Access Compliance Report

Public Rights-of-Way

Intersection ID: 5654	Main Street: JOHN_KIRK_DR	Cross Street: JOHN_KIRK_DR	Location: NW
ADA ID: E21AA5514840	Ramp Type: BlendTrans1	Initial Pass/Fail: Fail	Overall Compliance: No
		Severity Score: 1.25

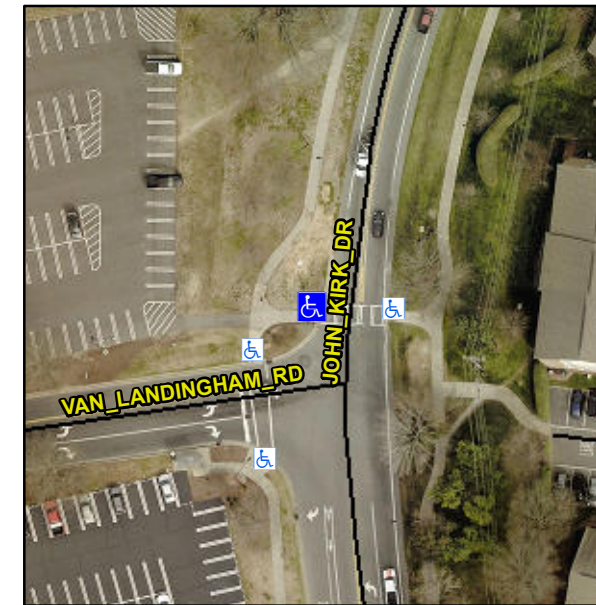
Not Found, R304.5.3

Remove & Replace Curb Ramp With Two New Directional Ramps or Equivalent.
